PIERCE COUNTY TERMINAL WHARF AND PHASE 2 DREDGING AND SLIP 5 MITIGATION CONTRACT NO. 998149

RECORD DRAWINGS

THESE RECORD DRAWINGS HAVE BEEN PREPARED BY ENGINEERING CONSULTANTS BASED UPON MARKUPS AND INFORMATION FURNISHED BY MANSON/TRAYLOR JV. WHILE THIS INFORMATION IS BELIEVED TO BE RELIABLE, THE CONSULTANTS CANNOT ASSURE ITS ACCURACY, AND THUS IS NOT RESPONSIBLE FOR THE ACCURACY OF THESE RECORD DRAWINGS OR FOR ANY ERRORS OR OMISSIONS WHICH MAY HAVE BEEN INCORPORATED INTO IT AS A RESULT. THOSE RELYING ON THESE RECORD DRAWINGS ARE ADVISED TO OBTAIN INDEPENDENT VERIFICATION ON THEIR ACCURACY BEFORE APPLYING IT FOR ANY PURPOSE. INFORMATION THAT IS CLOUDED REPRESENTS CHANGES MADE TO THE DESIGN DRAWINGS.

EP-~~551-17~~
C9
SHEET 14 OF 164
CONTRACT NUMBER: 998149
E NUMBER: E1972
PHASE: RECORD DOCUMENTS

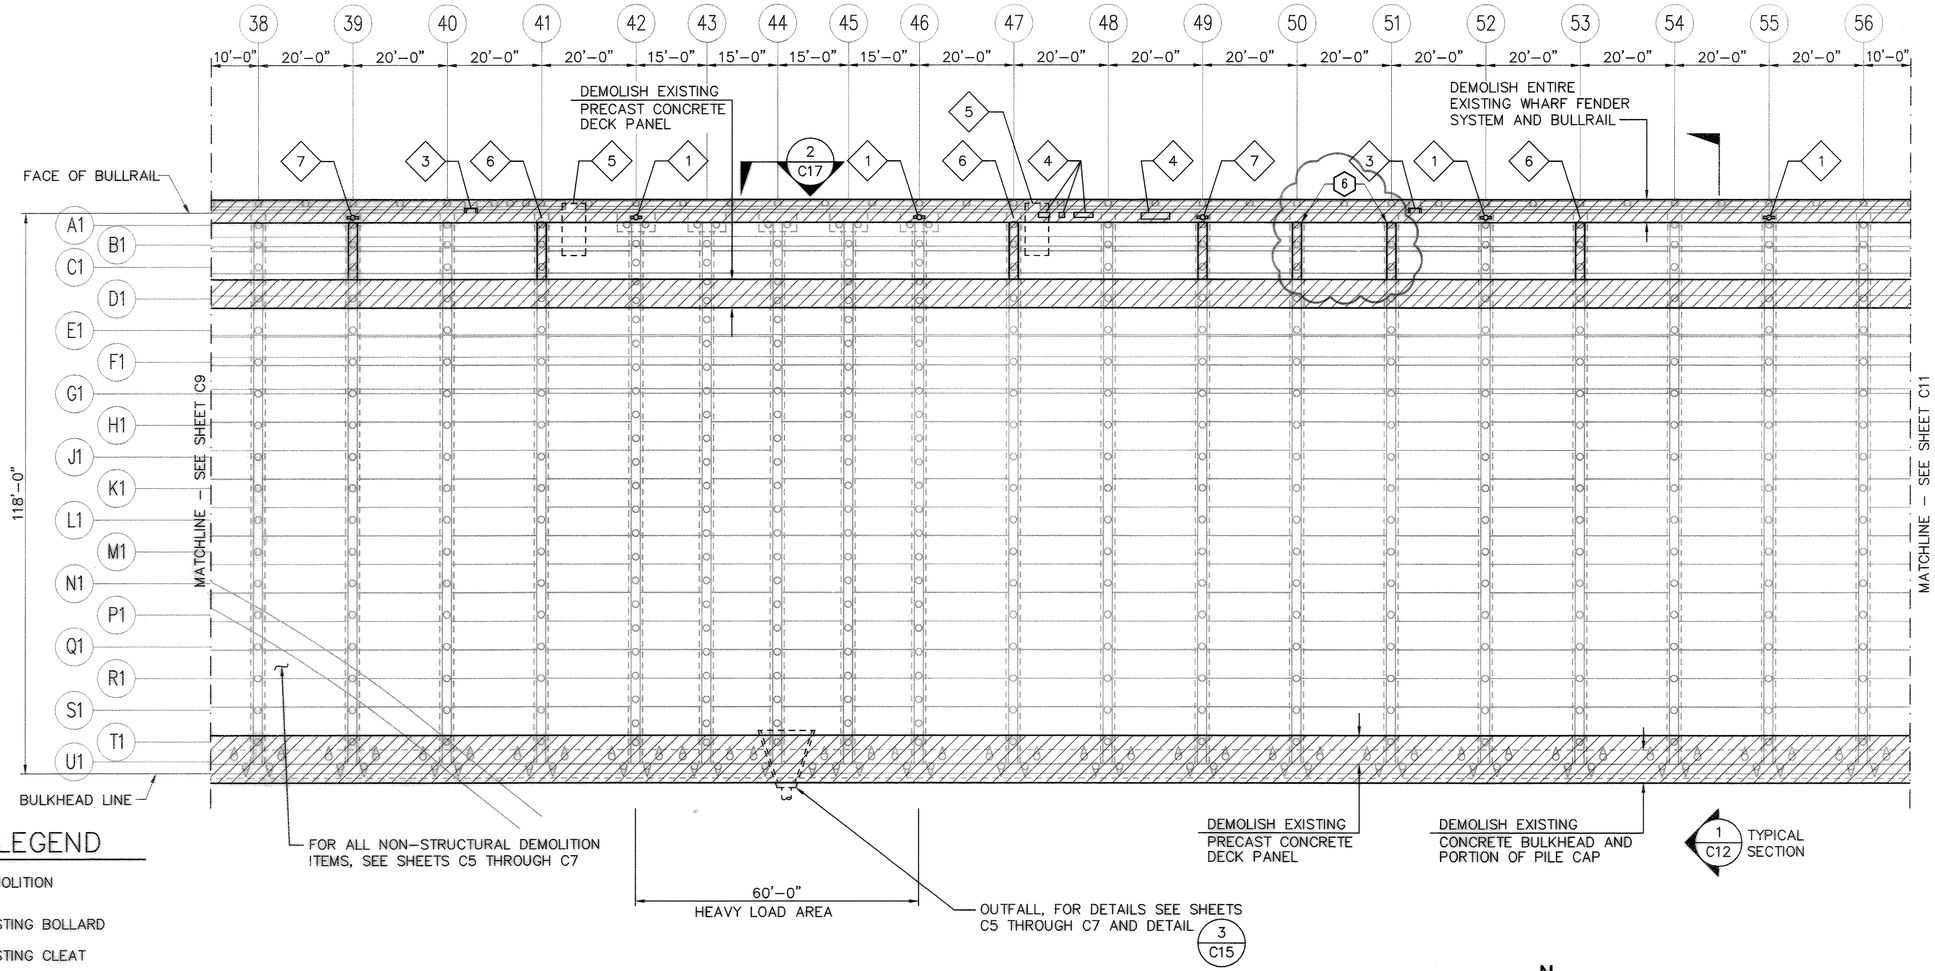
- DEMOLITION
- EXISTING BOLLARD
- EXISTING CLEAT
- EXISTING LADDER
- EXISTING UTILITY VAULTS
- 1 EXISTING BOLLARD DEMOLITION, SEE 2/C18 AND 5/C18
- 2 EXISTING CLEAT DEMOLITION, SEE 3/C18 AND 6/C18
- 3 EXISTING LADDER DEMOLITION, SEE 3/C19 AND 4/C19
- 4 EXISTING UTILITY VAULT DEMOLITION, SEE 5/C17
- 5 EXISTING CATWALK DEMOLITION, SEE 1/C19 AND 2/C19
- 6 EXISTING PILE CAP DEMOLITION FOR BOLLARD, SEE 1/C18 AND 4/C18
- 7 EXISTING BOLLARD DEMOLITION AND PARTIAL EXISTING PILE CAP DEMOLITION FOR BOLLARD, SEE 2/C18 AND 5/C18
- 8 EXISTING CLEAT DEMOLITION AND PARTIAL EXISTING PILE CAP DEMOLITION FOR BOLLARD, SEE 3/C18 AND 6/C18
- (6) ADDED DEMOLITION FOR NEW BOLLARDS 50, 51 PER RFP #4

SHEET 30 OF 164
C25

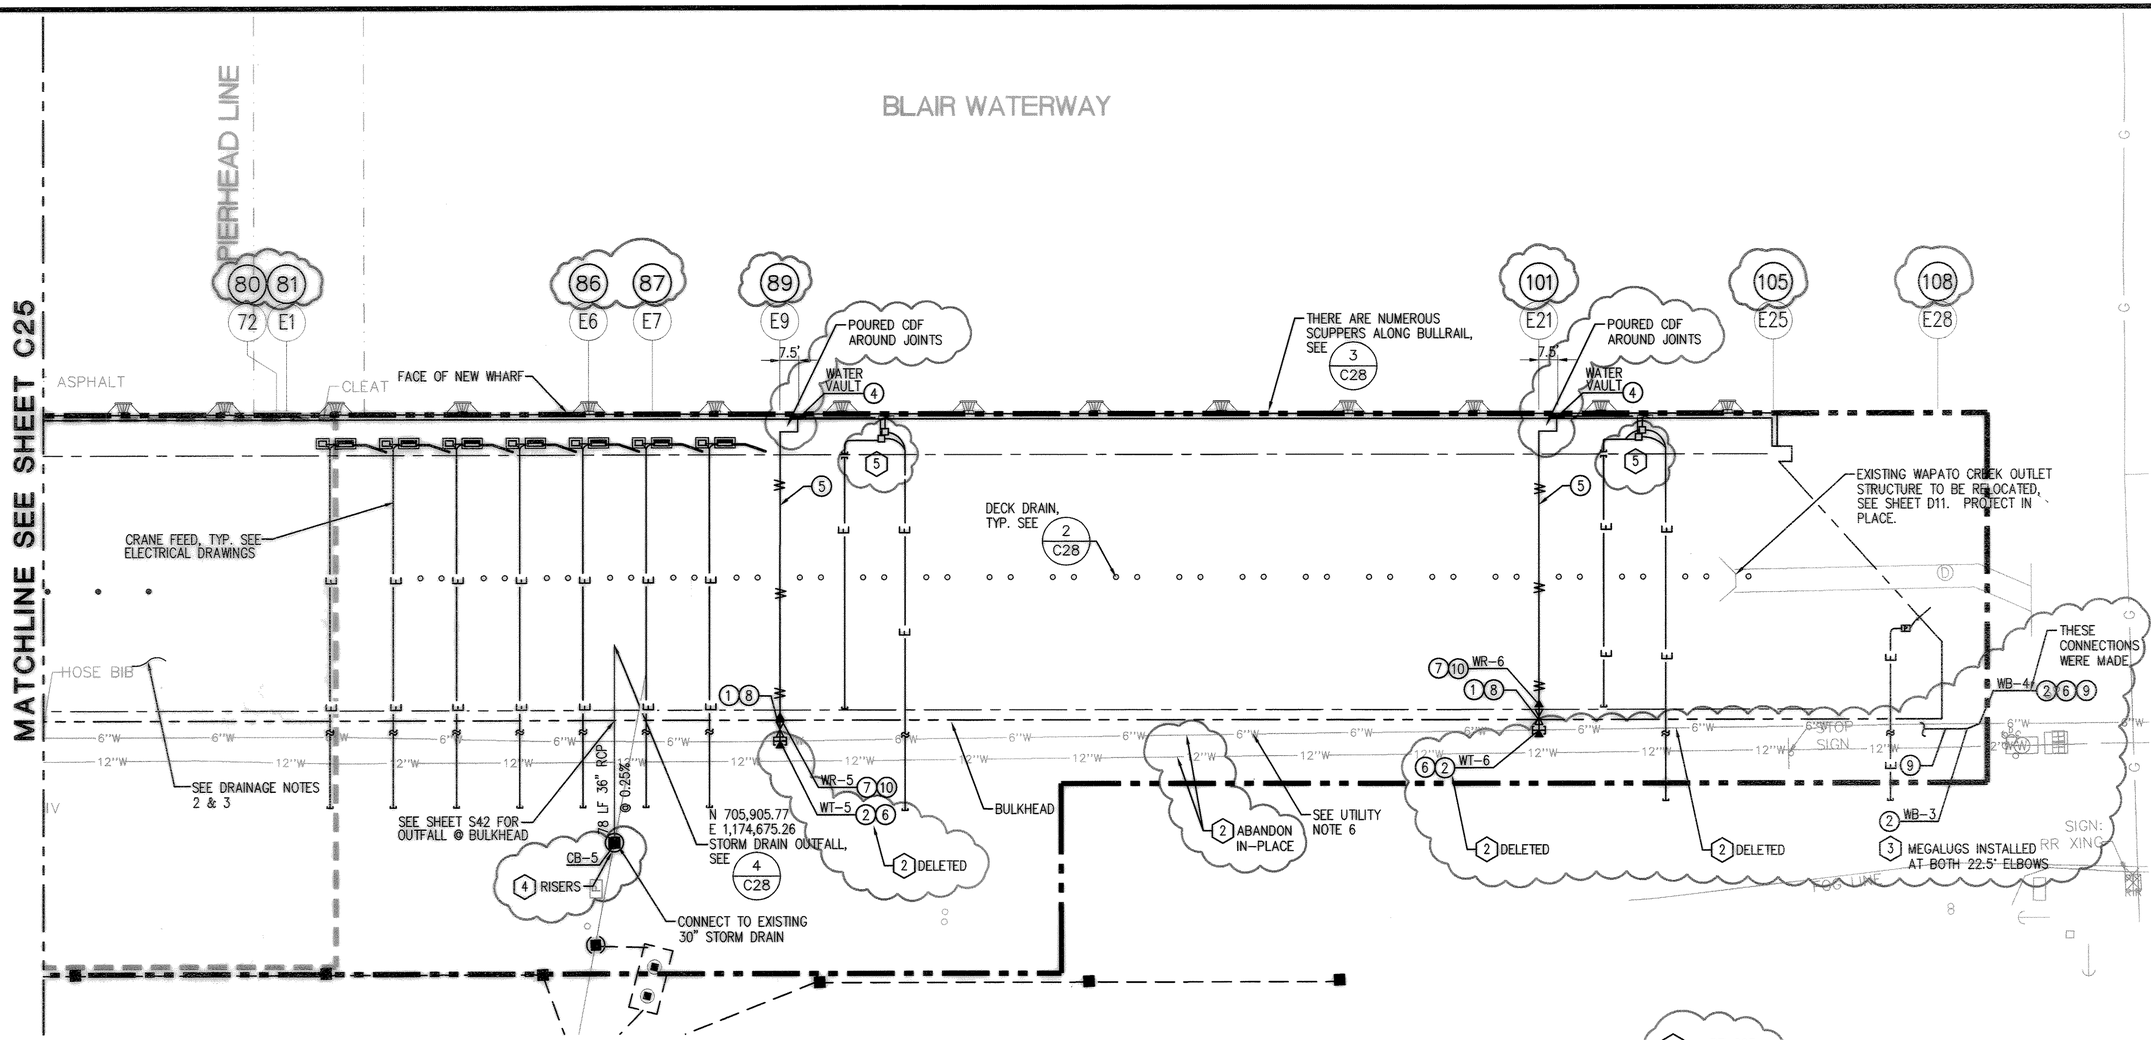
1. RFI 093
2. RFP 16
3. MEGALUGS INSTALLED AT BOTH 22.5°ELBOWS
4. SUBMITTAL 02400-08, SEE DWG H02 ON BACK OF C25.
5. ALL ELECTRICAL CONDUIT NORTH OF O/B CRANE BEAM ENCASED IN RED CDF.

EP-5561-17
S3
SHEET 38 OF 164

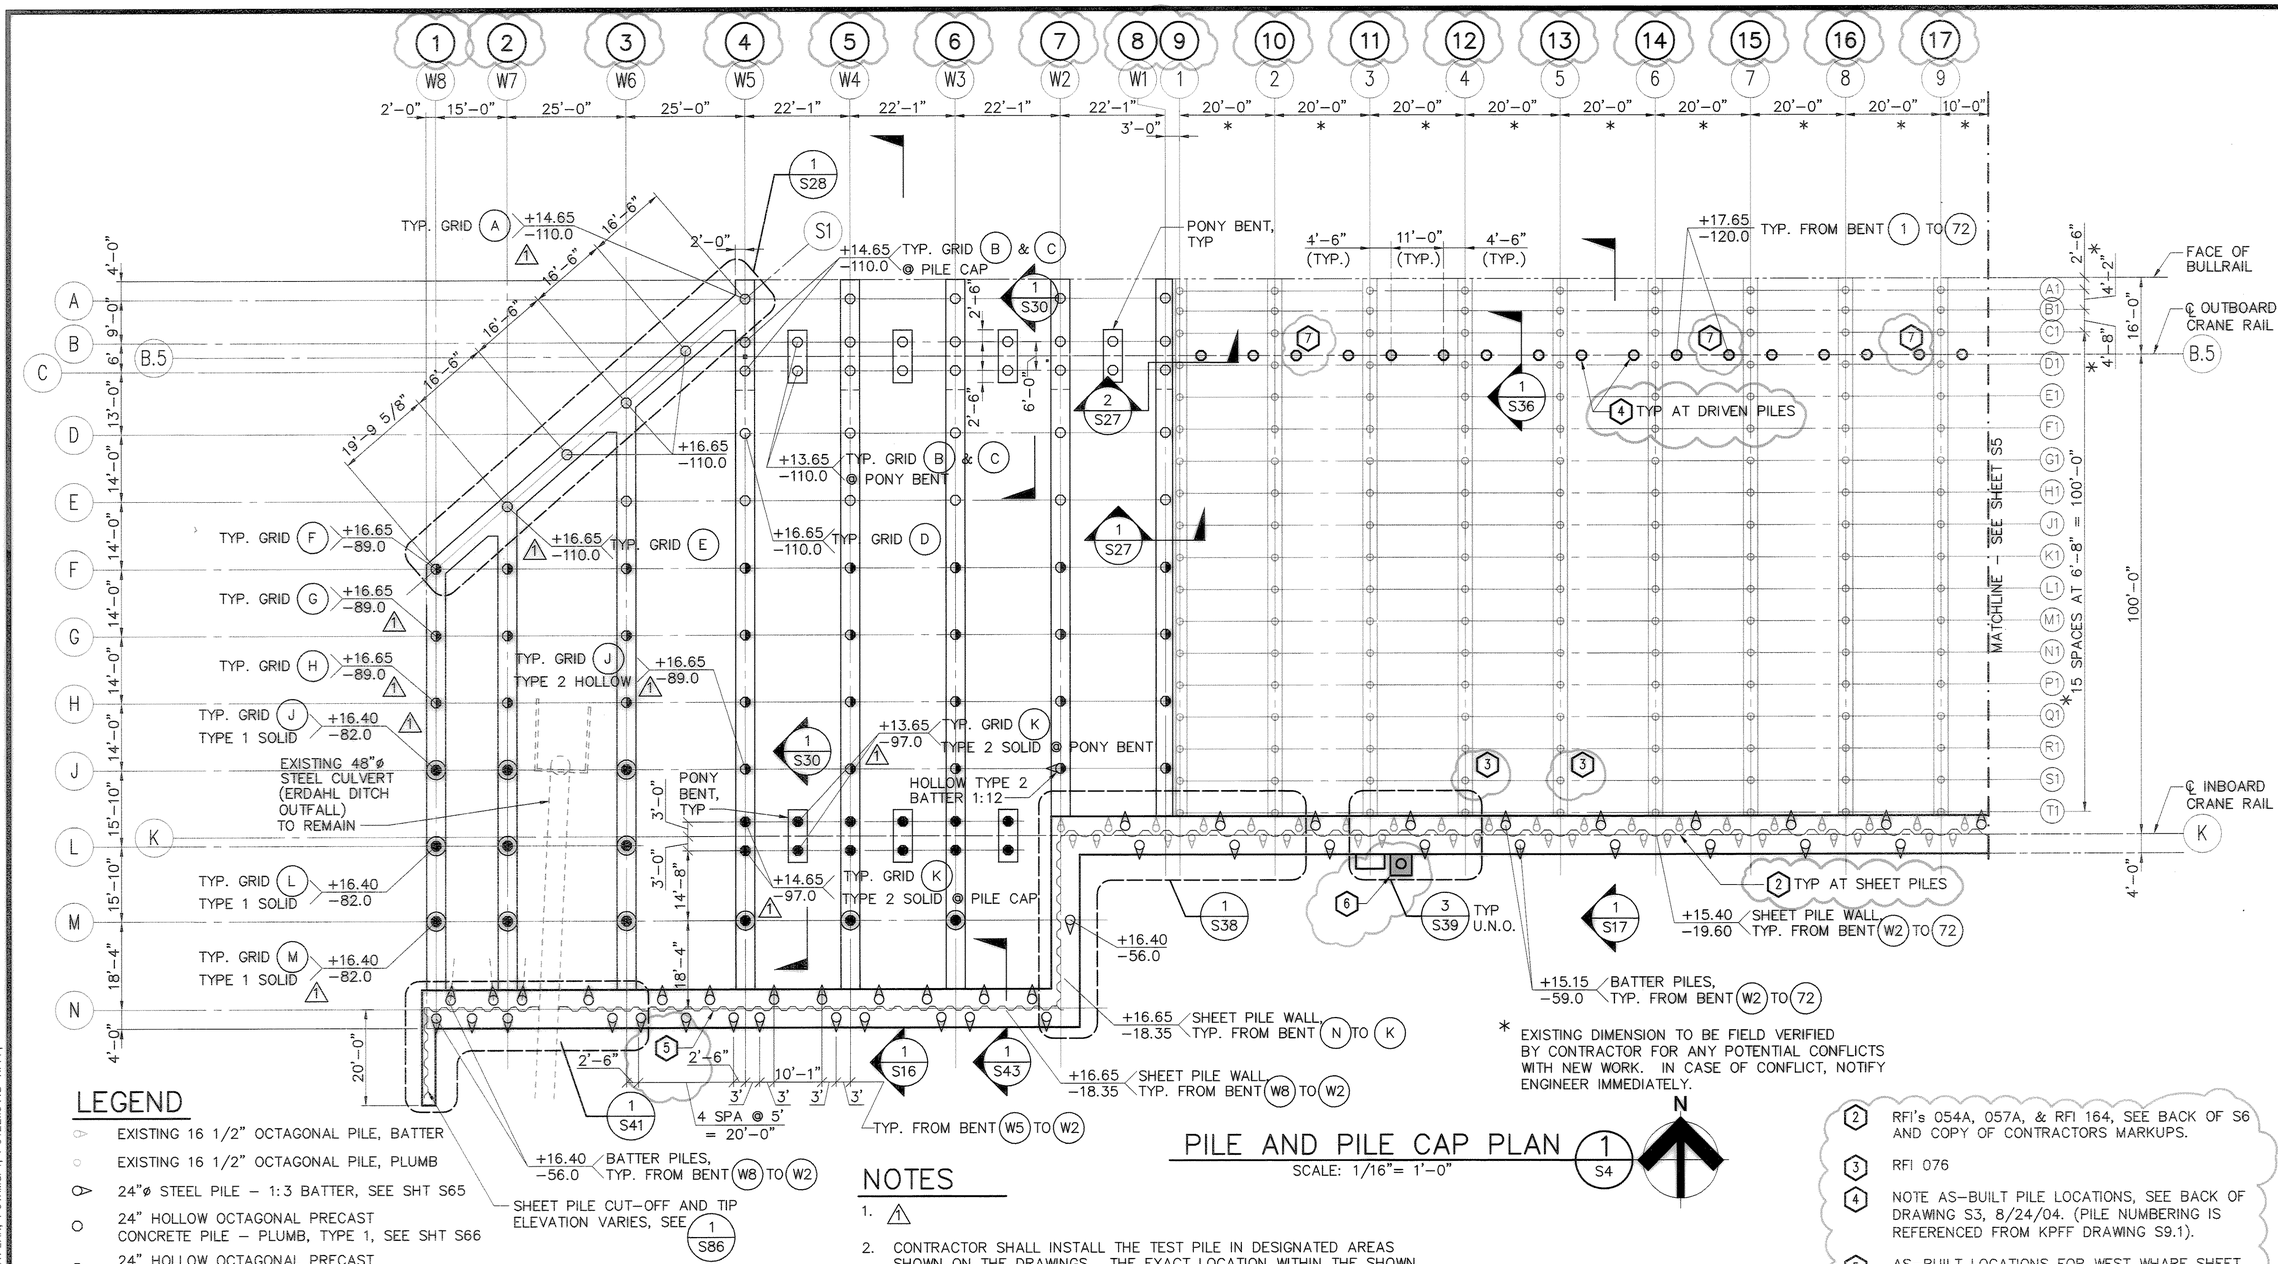
2. RFI's 054A, 057A, & RFI 164, SEE BACK OF S6 AND COPY OF CONTRACTORS MARKUPS.
3. RFI 076
4. NOTE AS-BUILT PILE LOCATIONS, SEE BACK OF DRAWING S3, 8/24/04. (PILE NUMBERING IS REFERENCED FROM KPFF DRAWING S9.1).
5. AS-BUILT LOCATIONS FOR WEST WHARF SHEET PILES & S1–S10 PIPE PILES. SEE BACK OF S3.
6. BULKHEAD REMEDIATION PILES, RE: POT TRANSMITTAL NO. 00420, SEE BACK OF S3.
7. MISALIGNED PILE TABOUTS, SEE KPFF DRAWINGS SK-1 AND SK-2.

SHEET 39 OF 164

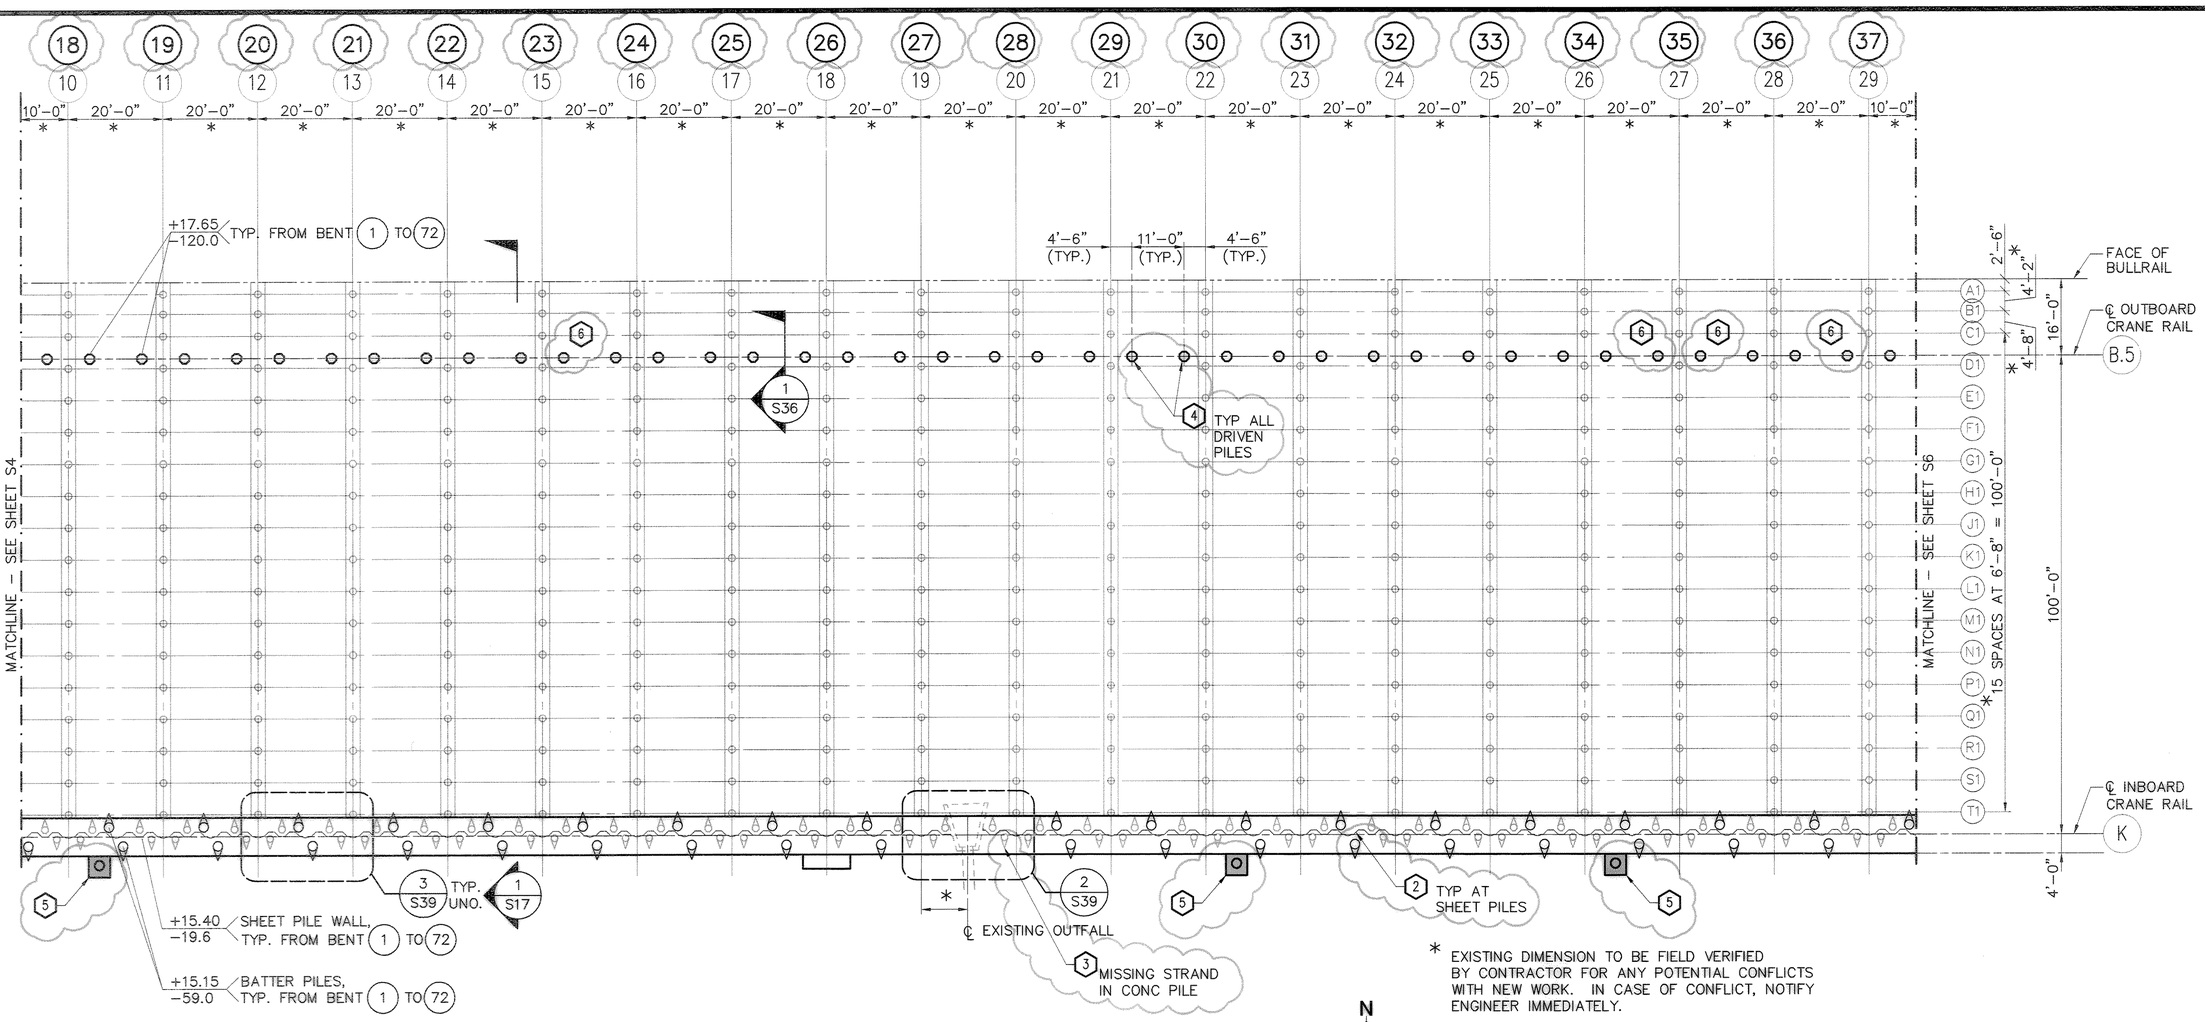
2. RFI 054A, 057A & 164, SEE BACK OF S6 AND COPY OF CONTRACTORS MARKUPS.
3. RFI 192
4. NOTE AS–BUILT PILE LOCATIONS, SEE BACK OF DRAWING S4. (PILE NUMBERING IS REFERENCED FROM DRAWING S9.1).
5. BULKHEAD REMEDIATION PILES, RE: POT TRANSMITTAL NO. 00420, SEE BACK OF S3.
6. MISALIGNED PILE TABOUTS, SEE KPFF DRAWINGS SK–1 AND SK–2.
